BULLETIN NO. 5

East Hampton Town Hall & Police Dept.

Addendum #2

This addendum is issued to show corrections, revisions and clarifications to the Bidding Documents for the Town of East Hampton – Town Hall and Police Department project, dated October 12, 2018.

FIRE PROTECTION PLAN -LOWER LEVEL

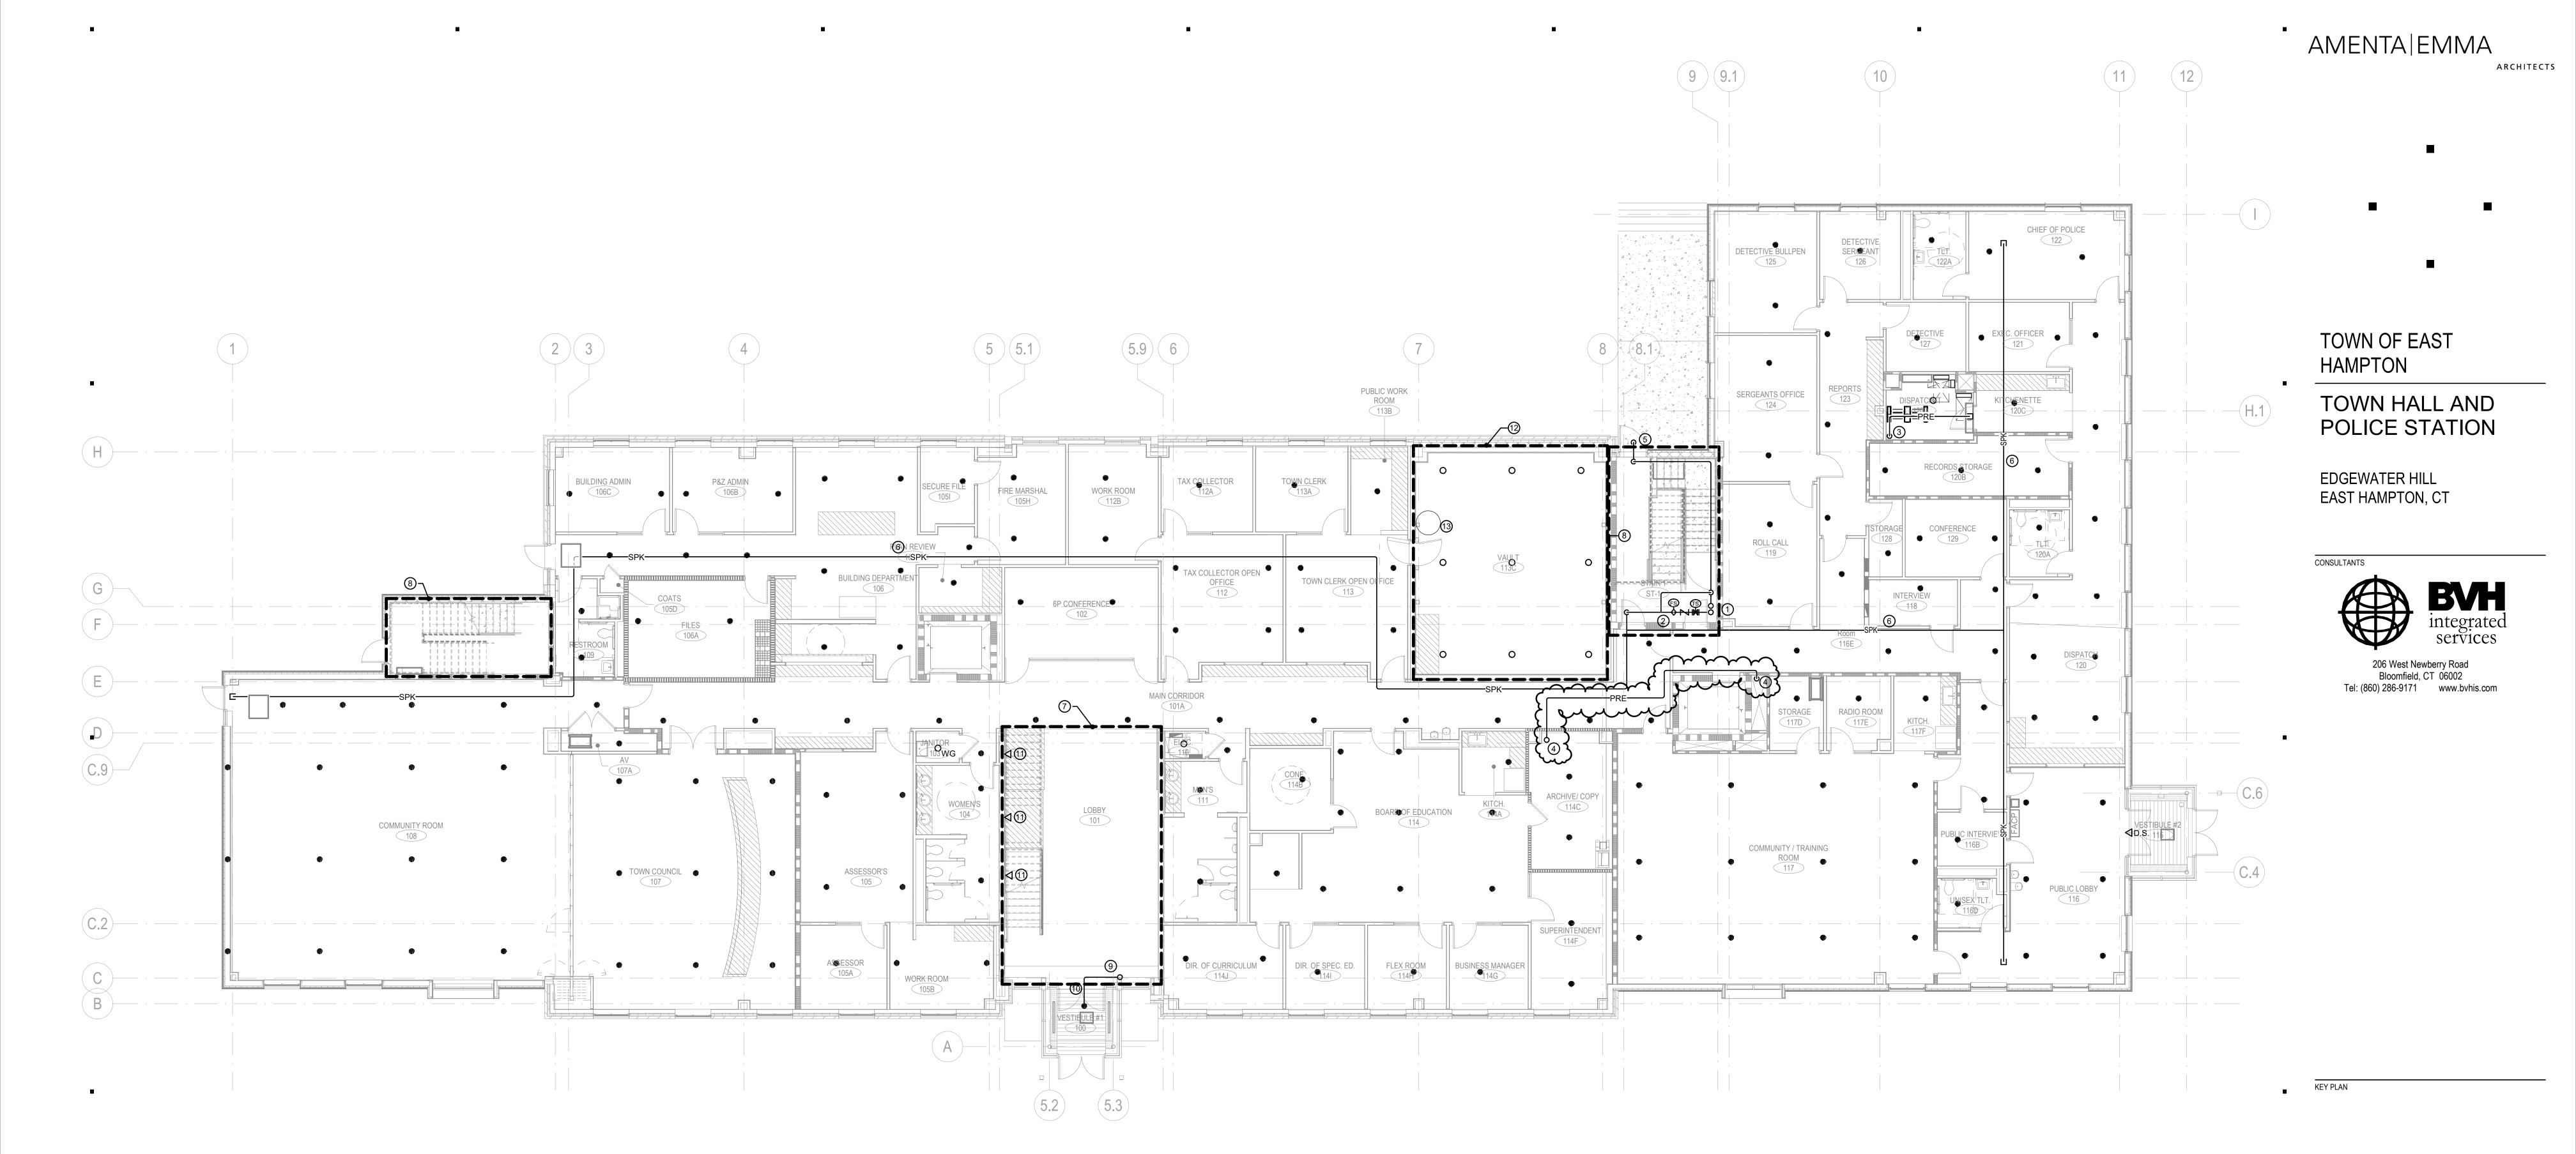
1. MODIFY drawings to clarify intent for pre-action system at Town Hall as it relates to Alternate #5.

PLUMBING PLAN - FIRST **FLOOR**

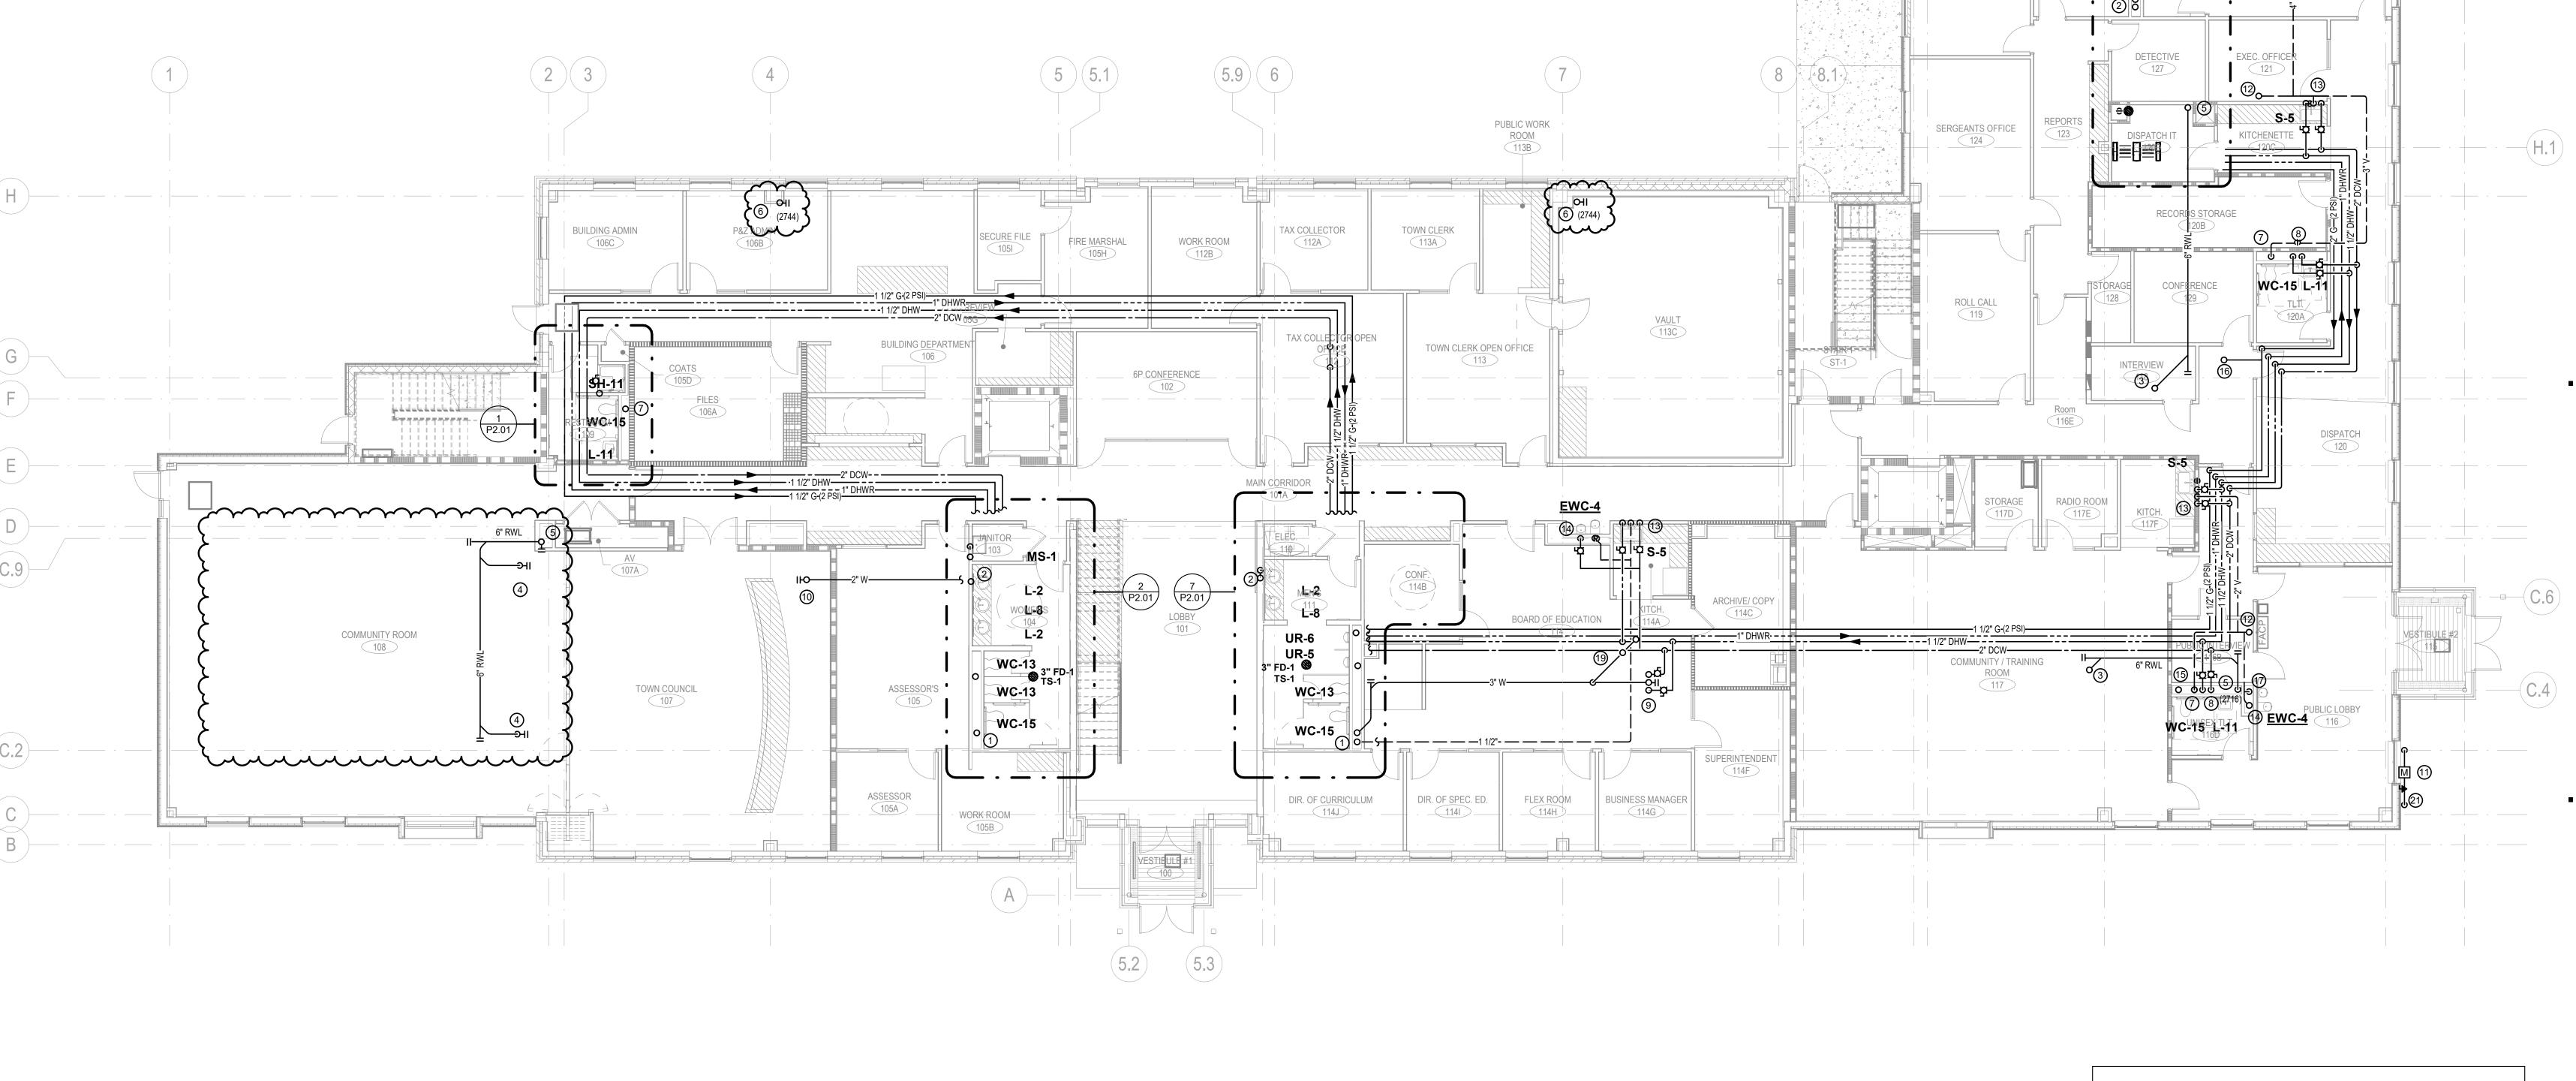
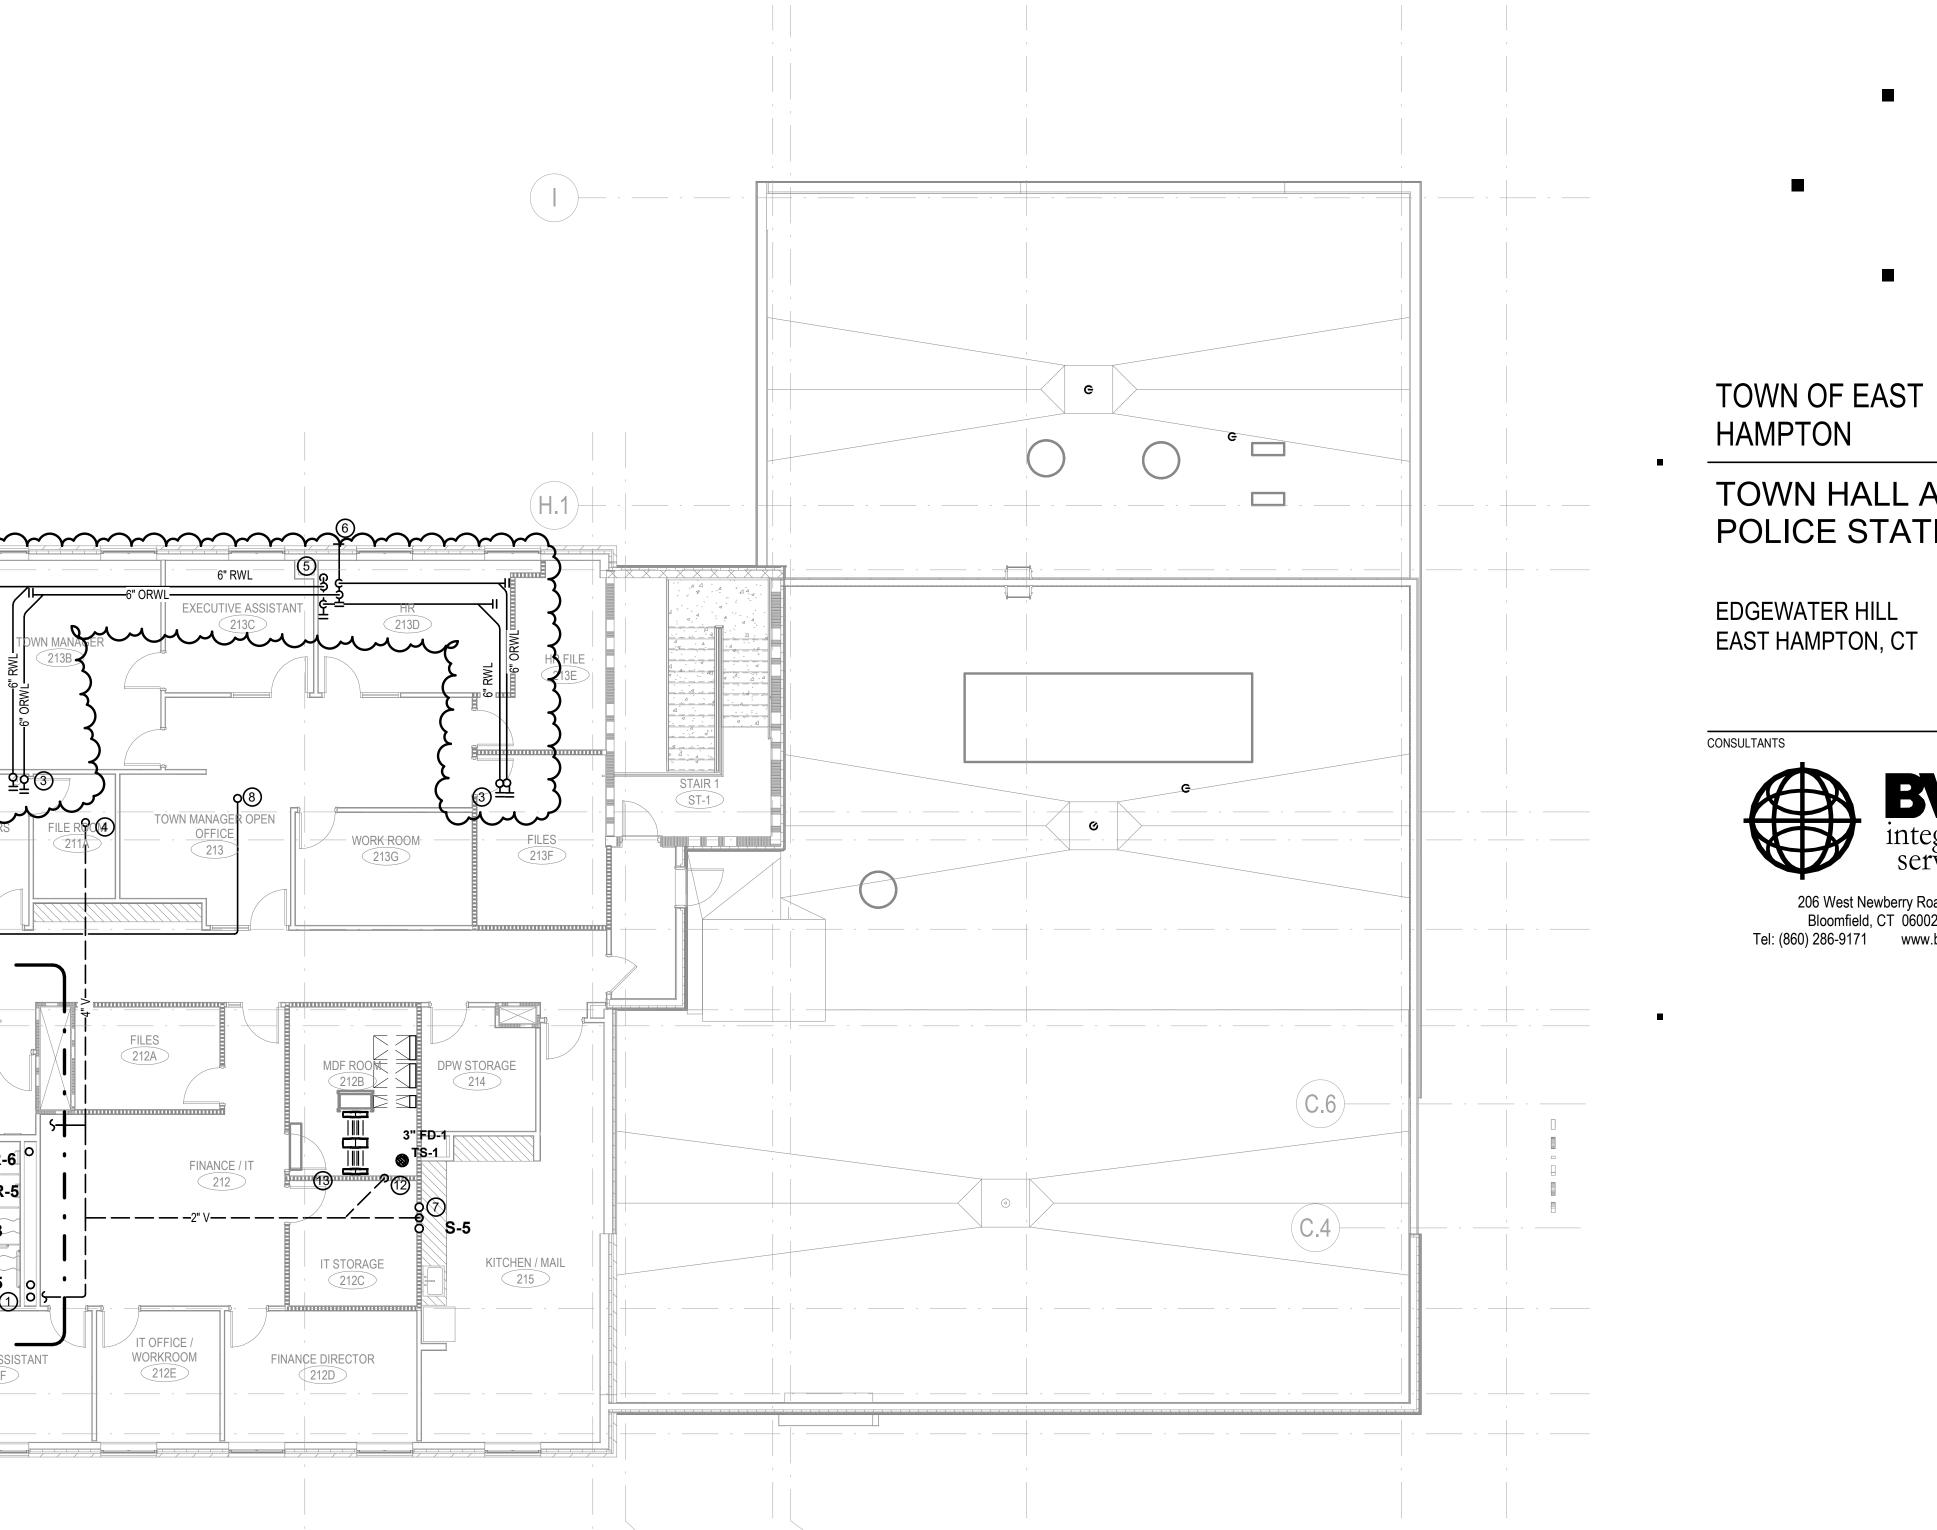
1. MODIFY rain-water leading pipe routing.
